Document ID 1292956	Version 1.0	Status Approved	Reg no	Page i (189)
Author Allan Hedin			Date 2011-09-09	
Reviewed by			Reviewed date	
Approved by Olle Olsson			Approved date 2011-09-11

SKB's handling of the regulatory review of the safety assessment SR-Can

This document describes how SKB has taken account of the outcome of the regulatory review of the safety assessment SR-Can. The review was reported in two identical documents issued by SKI and SSI, respectively; SKI Report 2008:23 and SSI Report 2008:04 E.

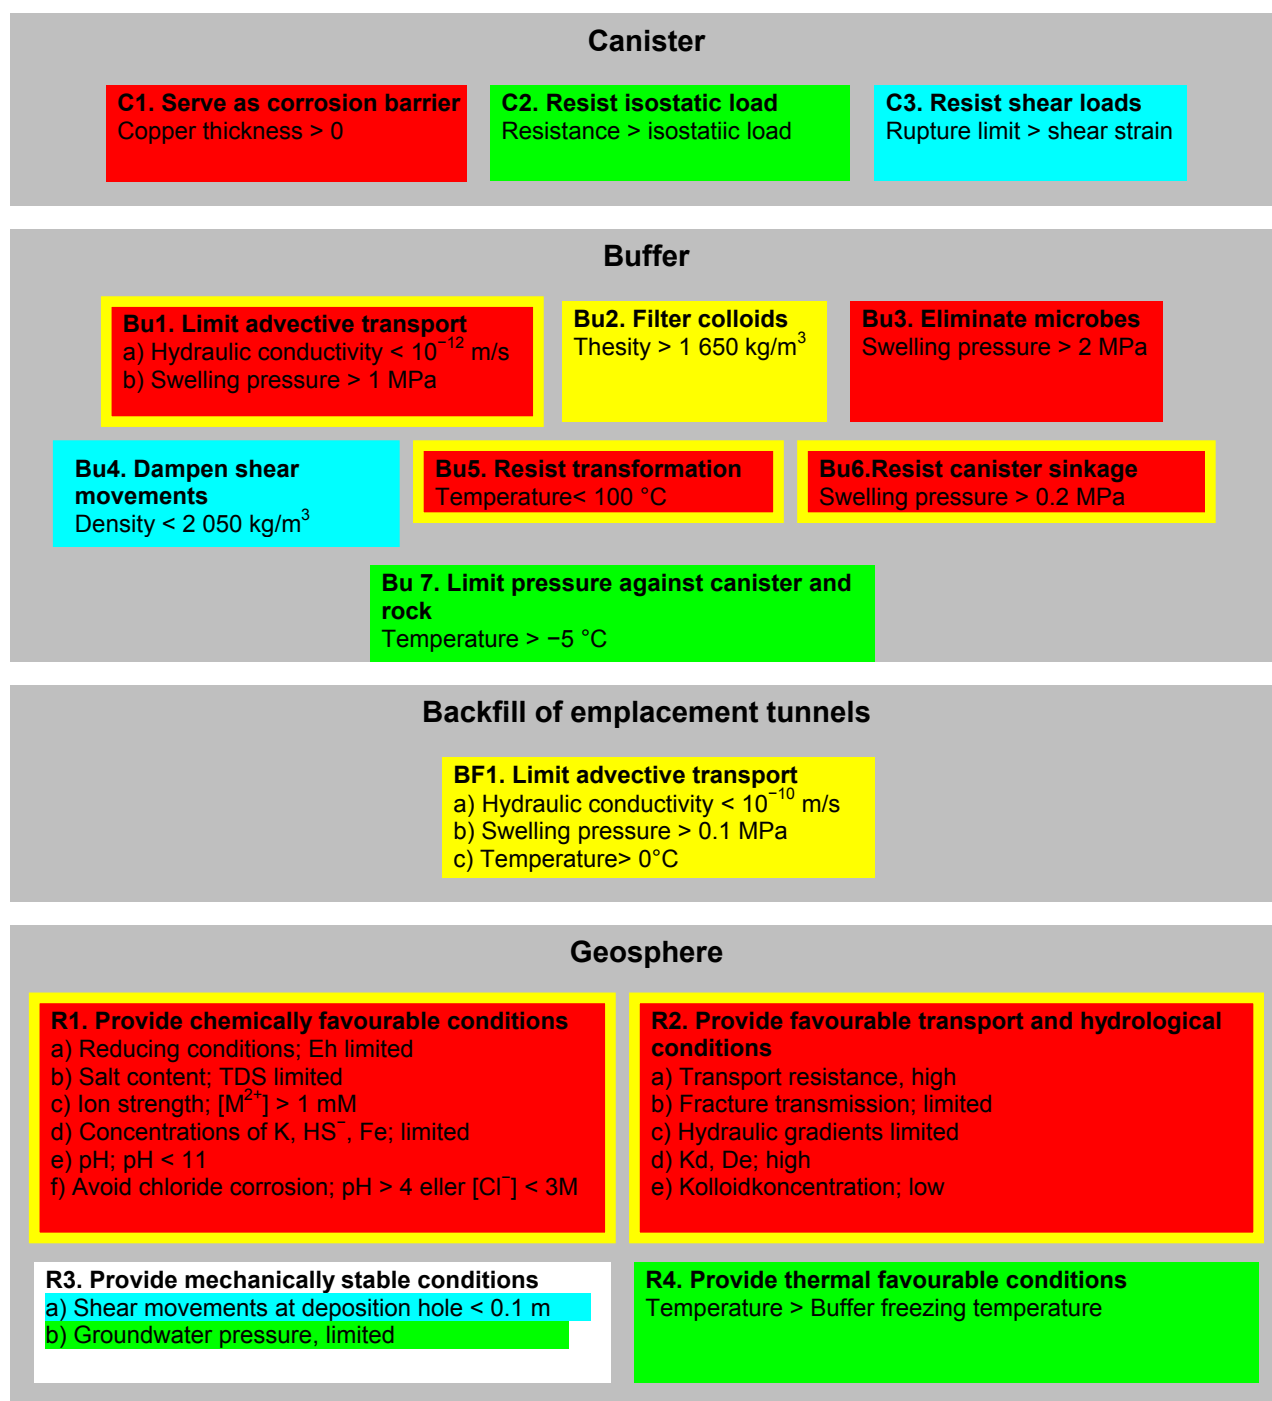
SAM considers that SKB should describe more explicitly how the different barriers contribute to the safety functions isolation and retardation. A report of this kind should include the relative importance of the barriers in different scenarios, and their importance to show that the repository system has a built-in reserve capacity. SAM considers that the analysis of the safety function indicators is a good complement to the analysis of radionuclide transport. However, a clearer description is needed of the

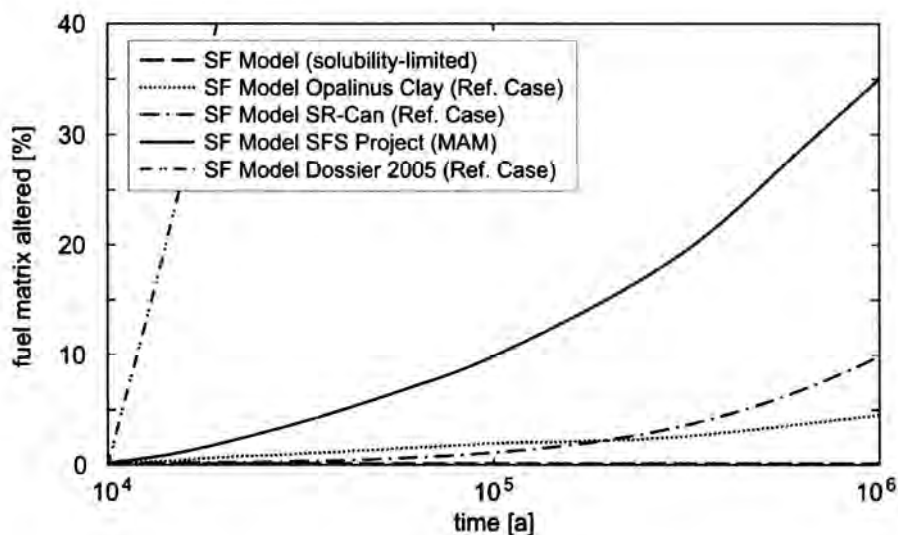
Opalinus Clay: the model is based on a fuel dissolution rate derived by back-calculating an effective G-value for hydrogen peroxide production (considering alpha-radiolysis only) using data from spent fuel and radiolysis experiments. A G-value of 0.01 was inferred.

SFS MAM: the model is based on kinetic studies of UO_2 dissolution, with the time-dependent oxidant production that drives the reaction derived from alpha-radiolysis calculations for groundwater at a H_2 partial pressure of 0.03 MPa. Surface reactions involving H_2 that may reduce oxidant concentrations are not simulated.

The following figure show the resulting fuel dissolution versus time for these models as well as for a model assuming solubility-limited dissolution

In the longer perspective when the radiolysis is negligible, a solubility-limited dissolution seems to be the most realistic approach. In that perspective, the SR-Can model is pessimistic.
